SYDNEY SWANS HQ & COMMUNITY CENTRE ROYAL HALL OF INDUSTRIES

RESPONSE TO GA NSW PLANNING SUBMISSION

PLANNING RESPONSE DOCUMENT – CMPT COMMENTS

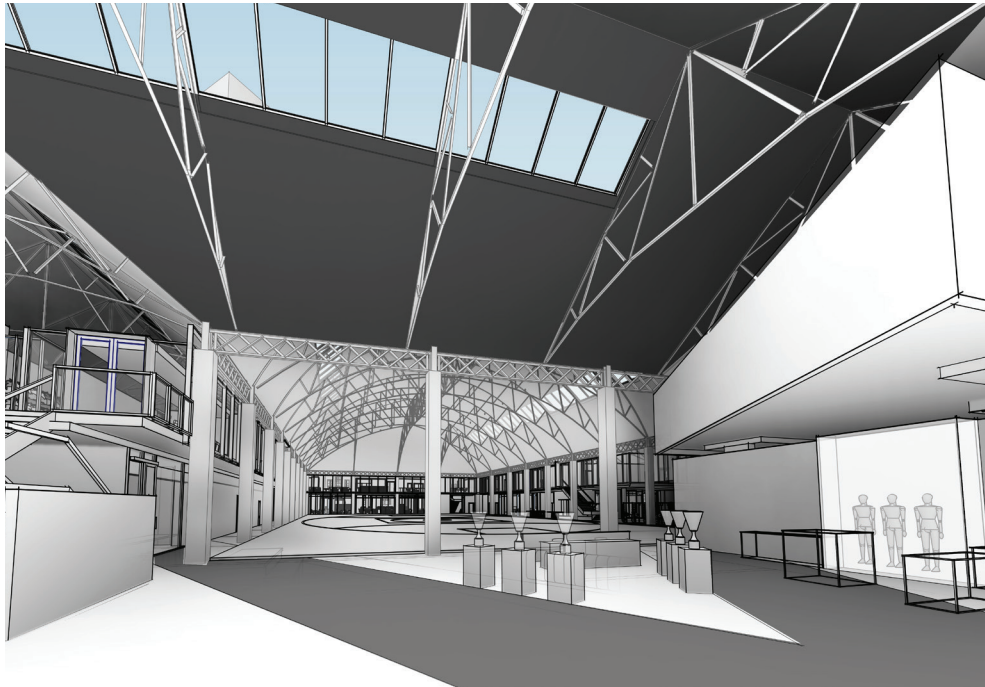
GA NSW Comment #1

Reduce or relocate the large program elsewhere on the site, which may include within the NSB, to ensure the integrity of the RHI's heritage significance and value, and the ability to provide adequate internal public space is not affected.

The images to the right provide a 3D study of the potential relocation of the Commercial Tenancy program to the NSB. Another storey has been added to the current design to demonstrate how this will impact the form and massing of the NSB building (Figure 1 & 2). It illustrates that the NSB through its larger scale would become the dominant building on this site which we believe, along with CMPT, is not the preferred outcome.

Figure 1. Scale comparison of the NSB to the RHI in proposed design. The NSB's annexe portion of the building shares the same height as the fascia edge of the RHI, rendering the two buildings as complementary in scale.

Figure 2. Scale comparison of the NSB to the RHI with an added level to accommodate tenancy. The view down corridor shows the difference in height between the RHI and the NSB tenancy. The third level of the annexe exceeds the height of the netball court as well as the fascia line of the RHI.

Sectional Perspective showing retention of Central Hall with the insertion of Indoor Multipurpose Area

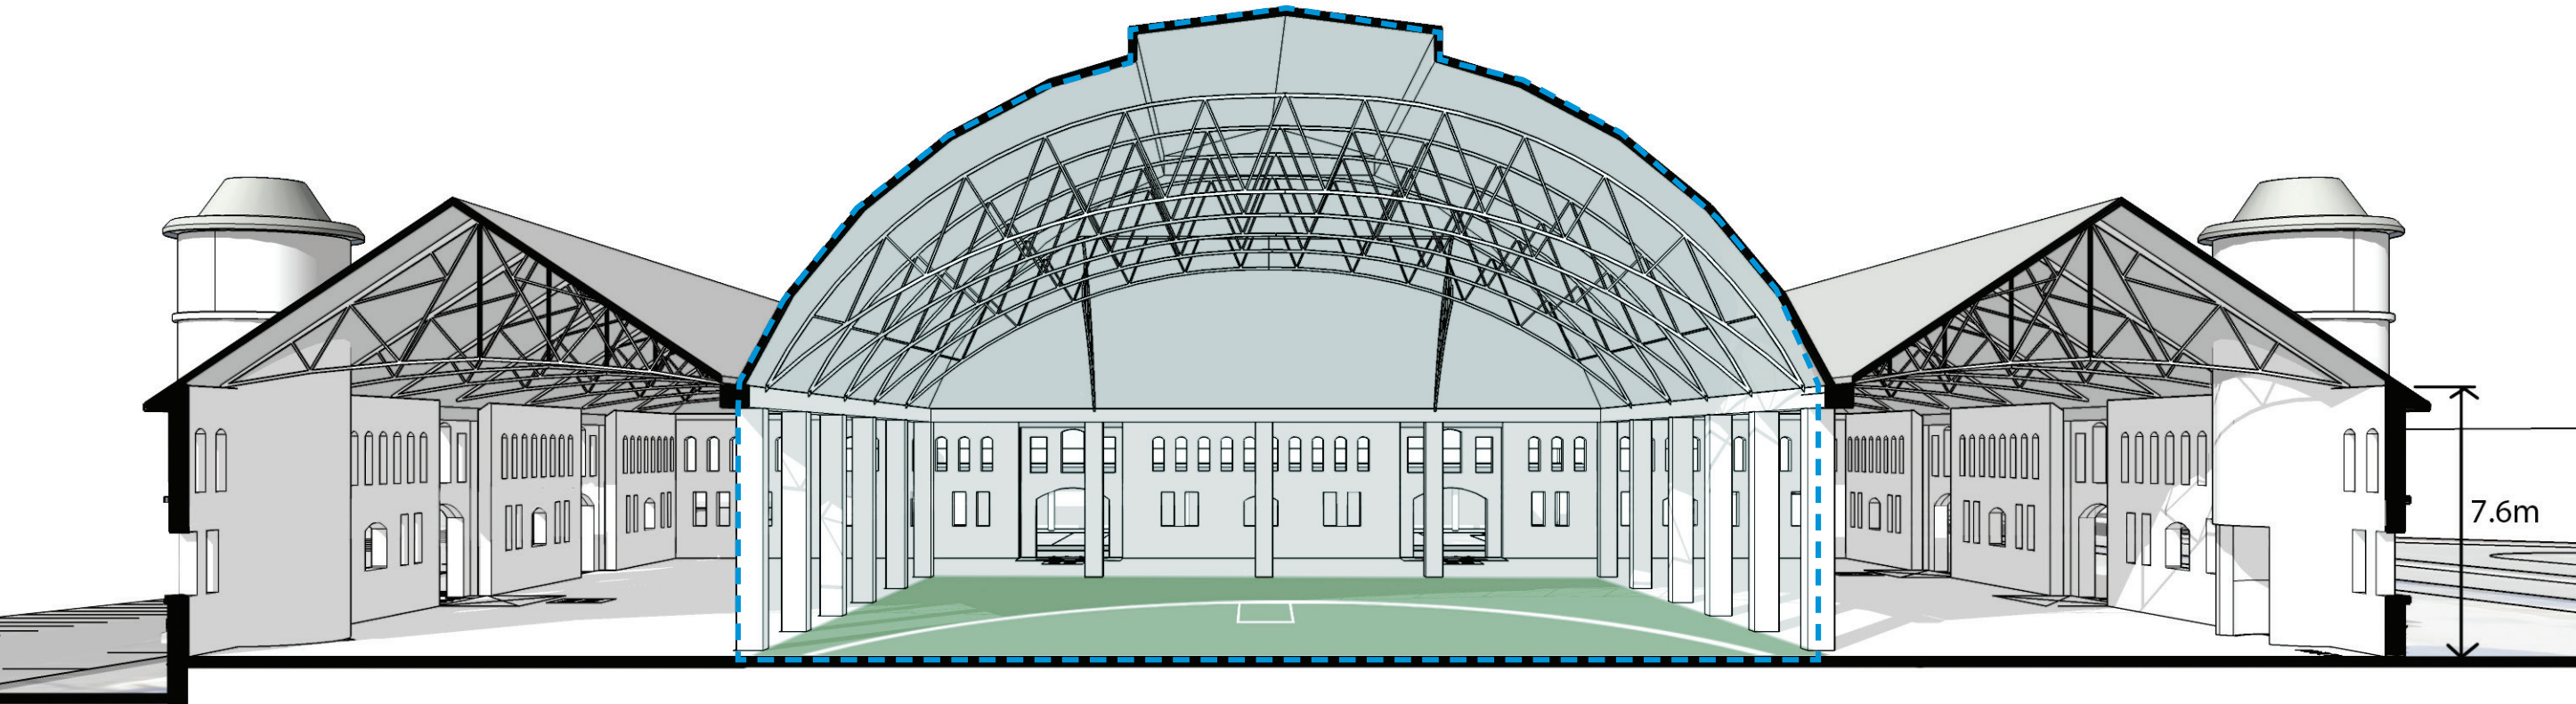
Provide a clear philosophy/language for the internal architecture to ensure it reads as a respectful and reversible insertion into the existing RHI.

Notwithstanding the challenge of inserting new program, the new refurbishment will retain and promote the existing hall's open volumes wherever possible. Full height spaces will be preserved around the building's key entry points and gym space.

As the focal point of the new configuration, the central barrel vault space will be maintained as a Multi-purpose Indoor area. The vista to this key space is immediately apparent from the building entry, that is also a double height space as well, as demonstrated by the image to the right, providing a captivating arrival experience that promotes the RHI's grand volume.

Cutaway perspective showing extent of mezzanine

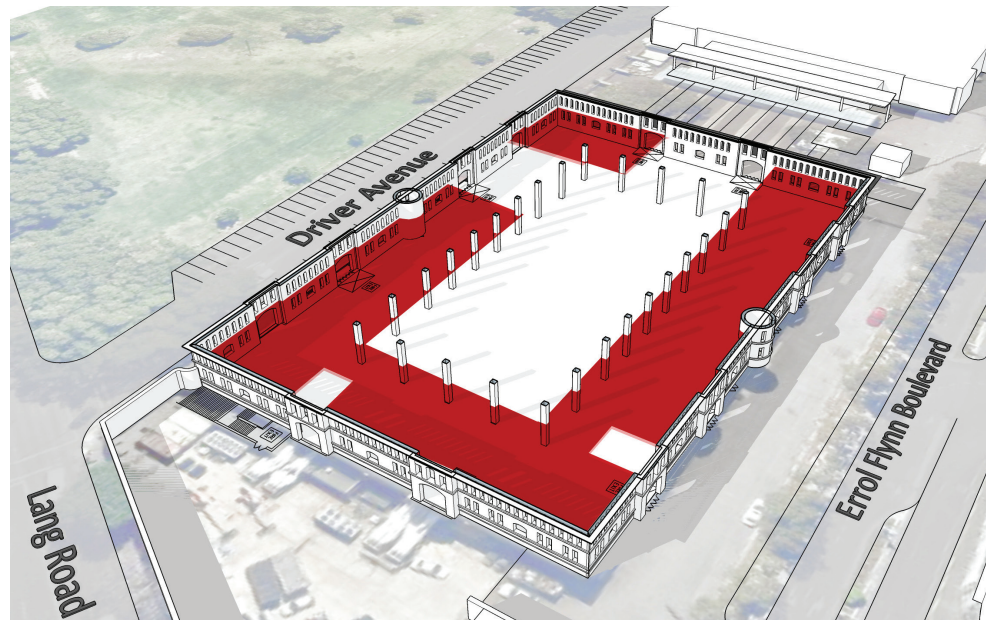
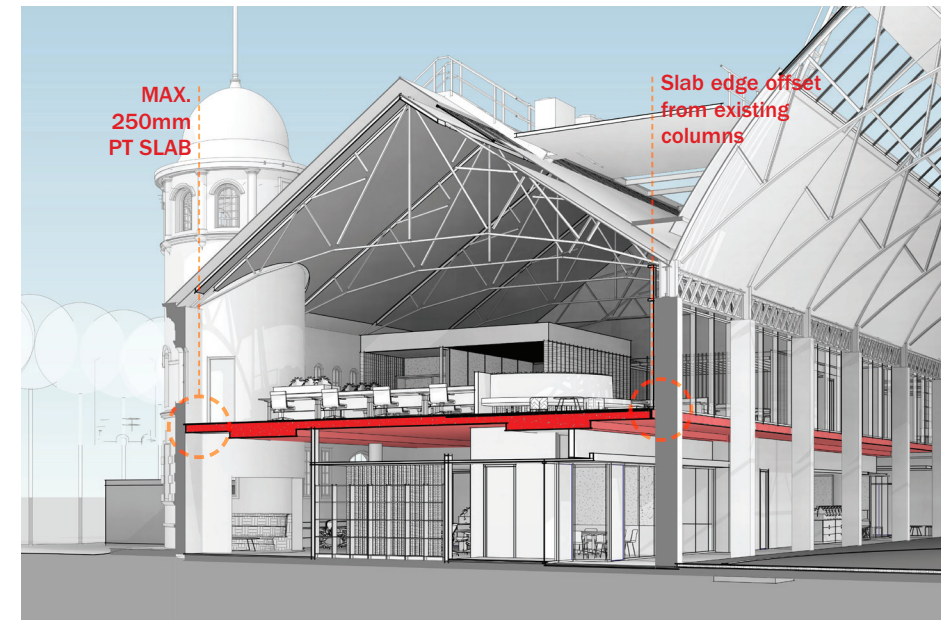
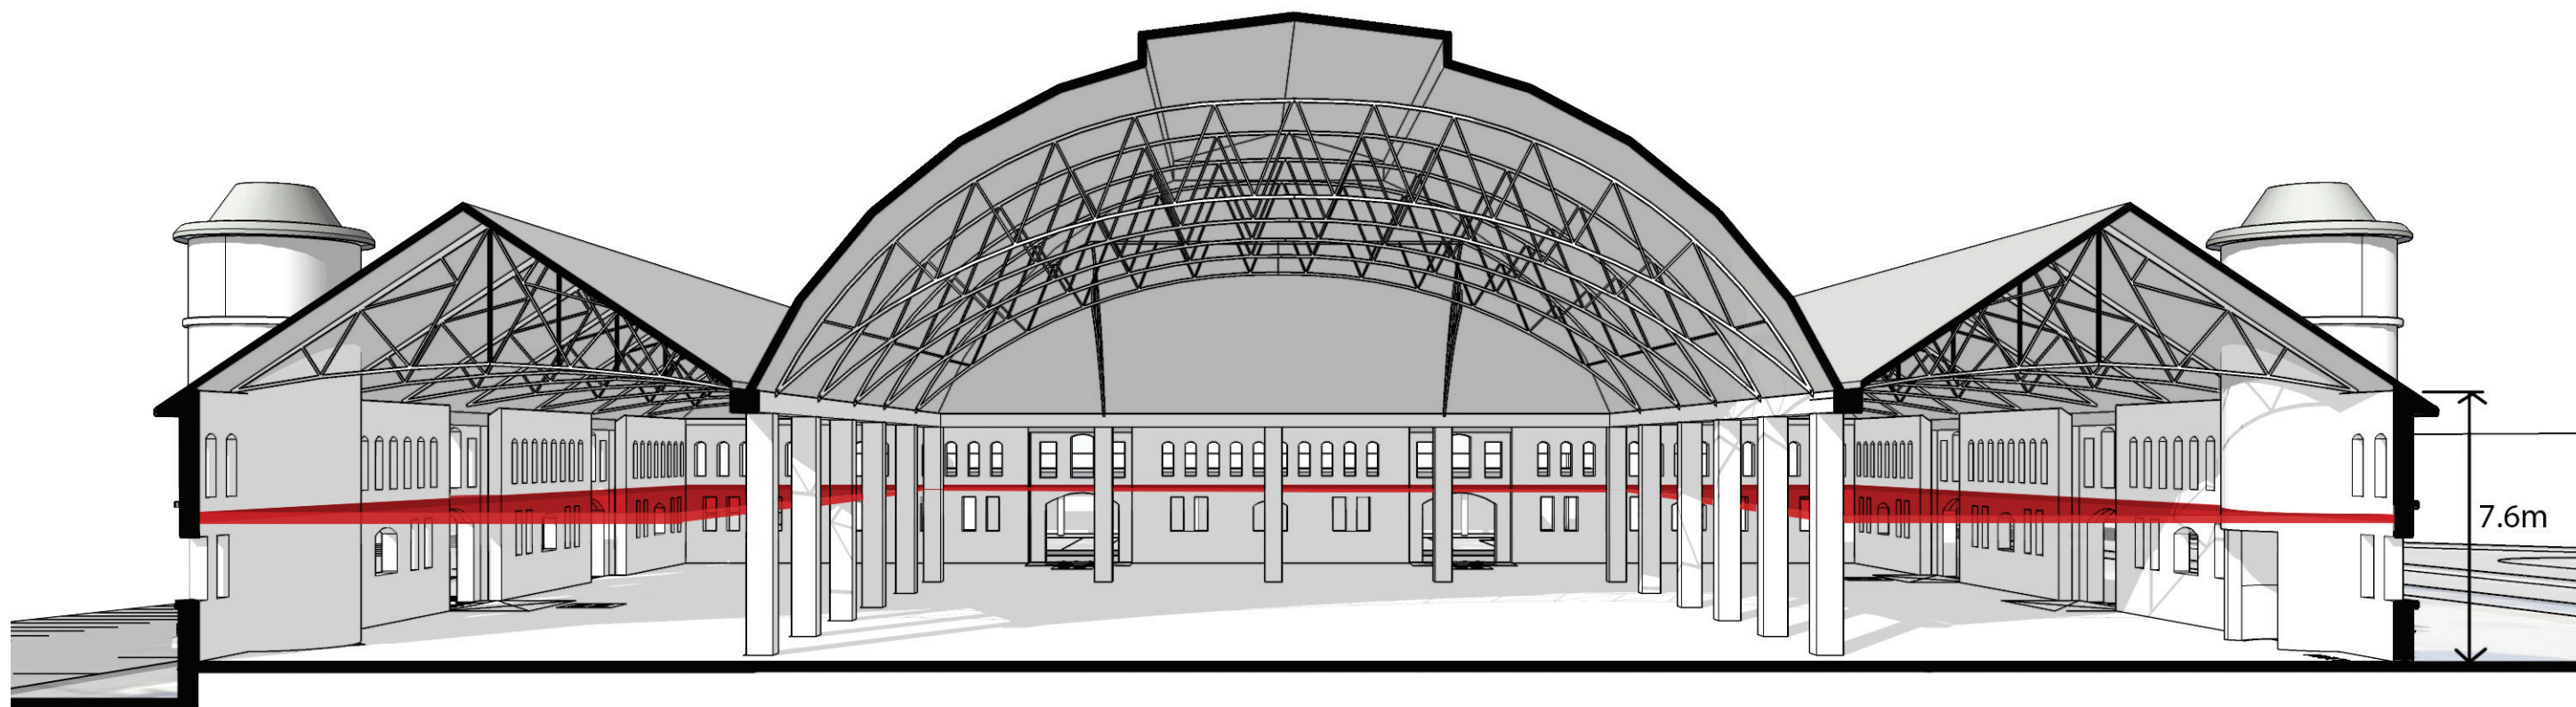
Provide a clear philosophy/language for the internal architecture to ensure it reads as a respectful and reversible insertion into the existing RHI.

Around the perimeter of the central hall, the development proposes the construction of a new mezzanine to increase usable floor space to accommodate the required new program.

The mezzanine will be structurally independent of the existing RHI building lightly touching the existing fabric. The columns for the new mezzanine are new and separate to the existing columns and can be removed at the completion of the lease with limited impact to the existing slab and foundations.

3D Section showing how new insertions lightly touch and interface with the existing fabric

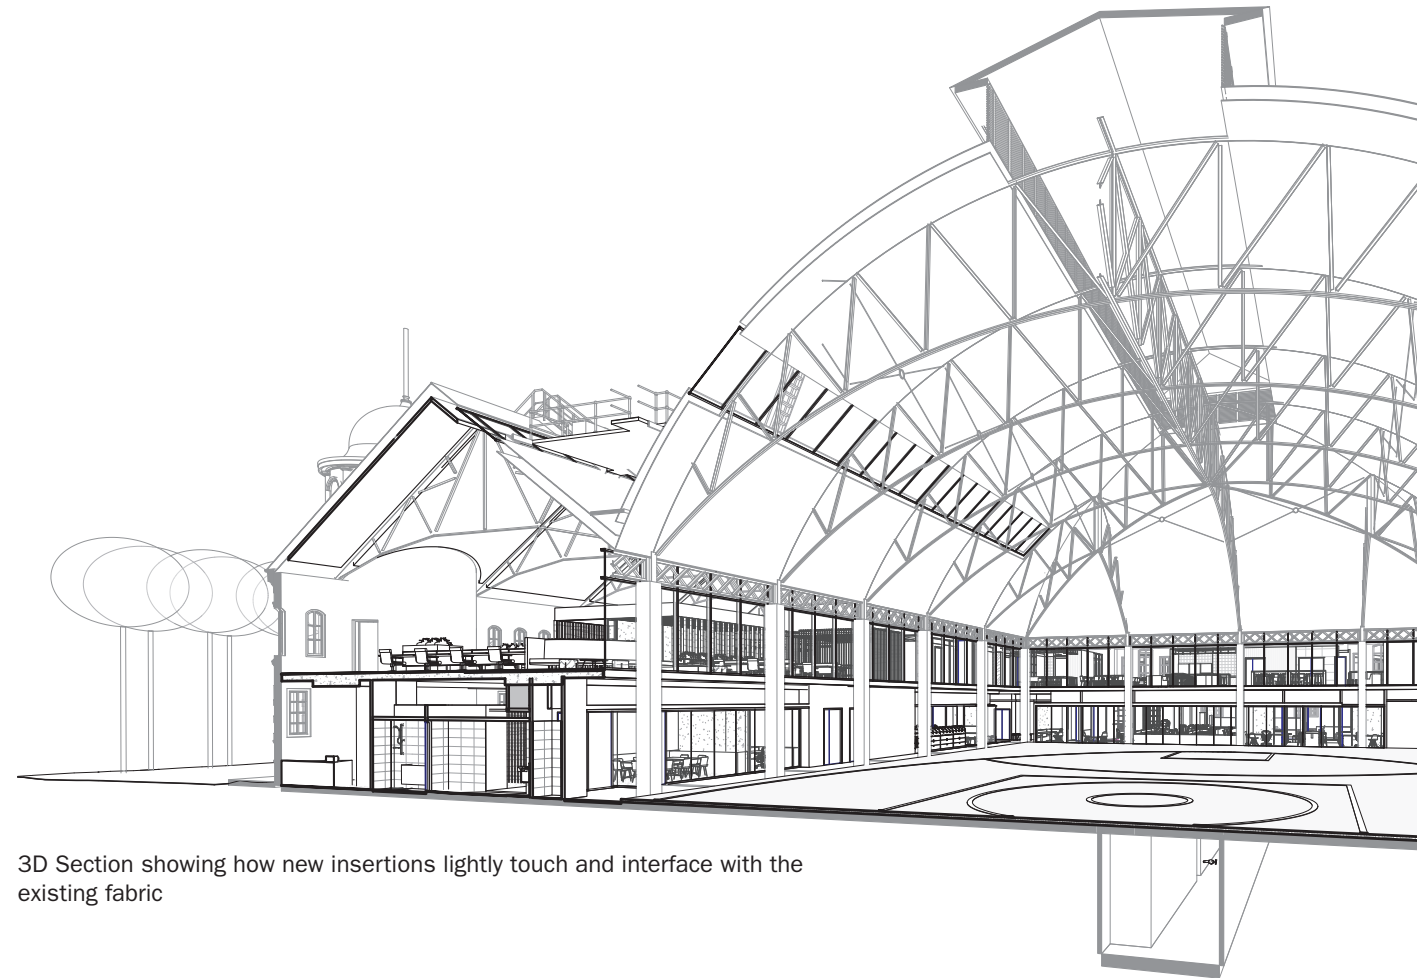
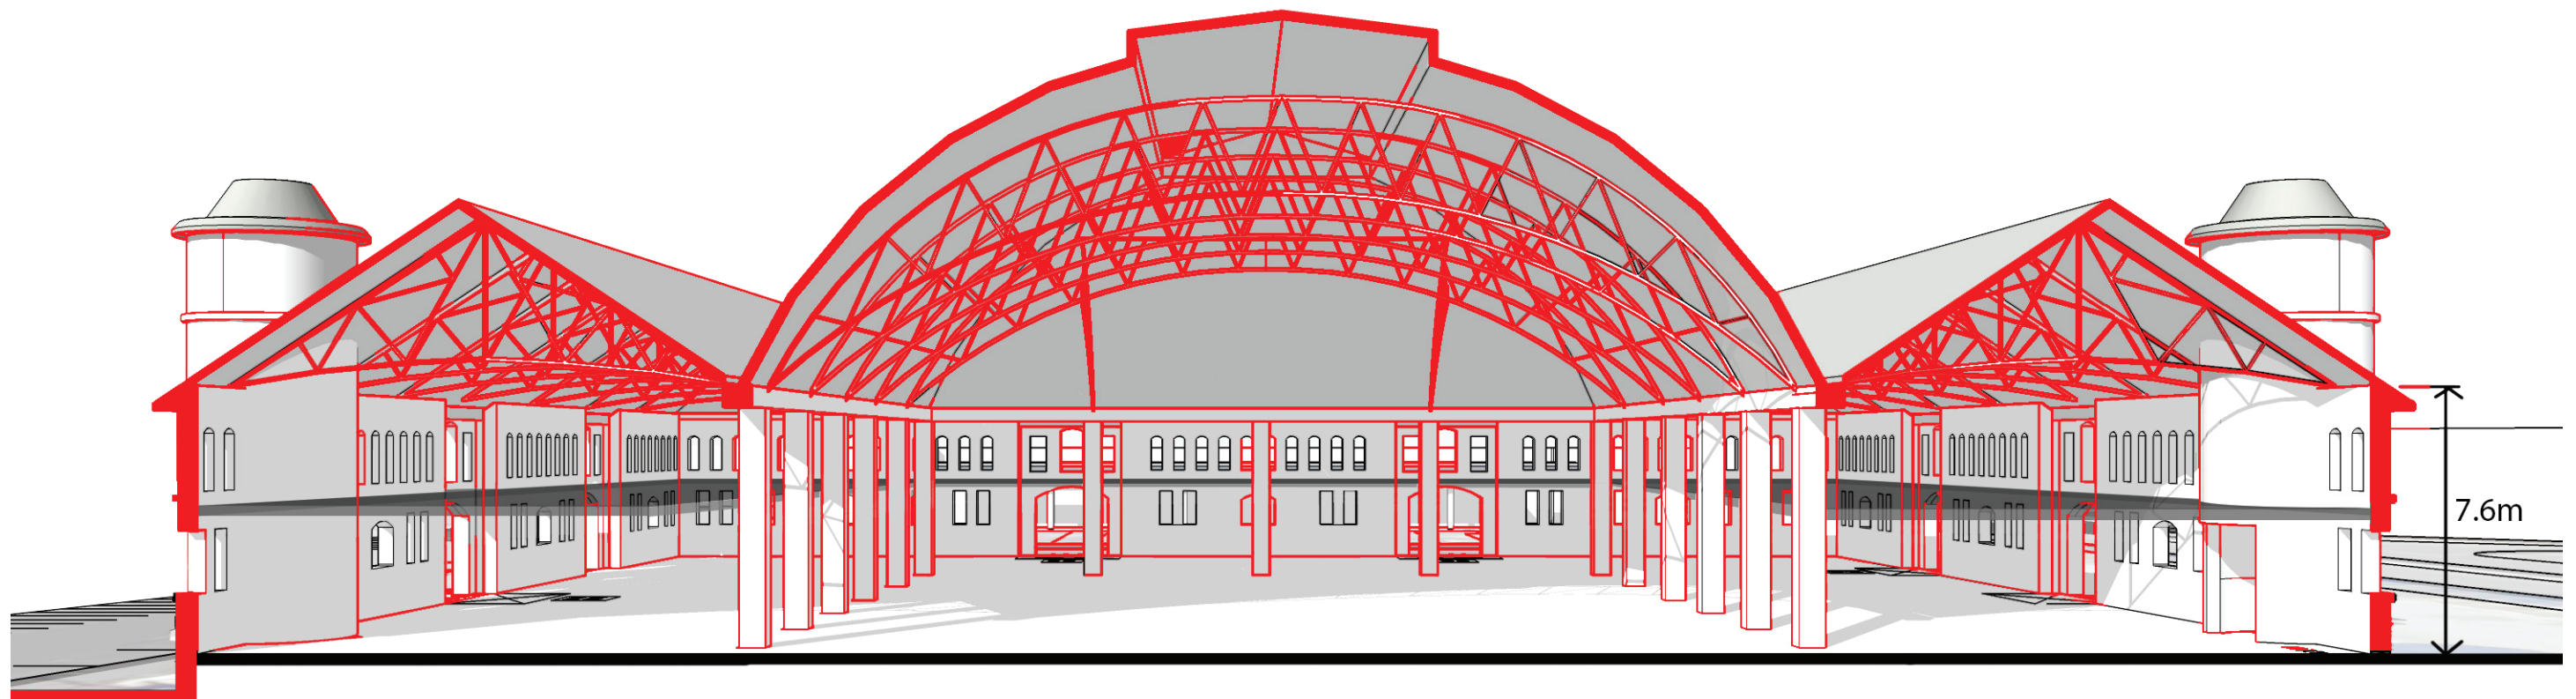
Provide a clear philosophy/language for the internal architecture to ensure it reads as a respectful and reversible insertion into the existing RHI.

The new fit out is designed to read as a 'loose fit' within the existing RHI structure. The perimeter walls to the central hall have been recessed to better express the central hall colonnade and full height walls within the refurbishment have been minimised to allow the roof trusses to be expressed openly throughout the new mezzanine level.

The level of the mezzanine is strategically positioned to ensure the windows of the RHI are appropriately located on both levels and expressed architecturally.
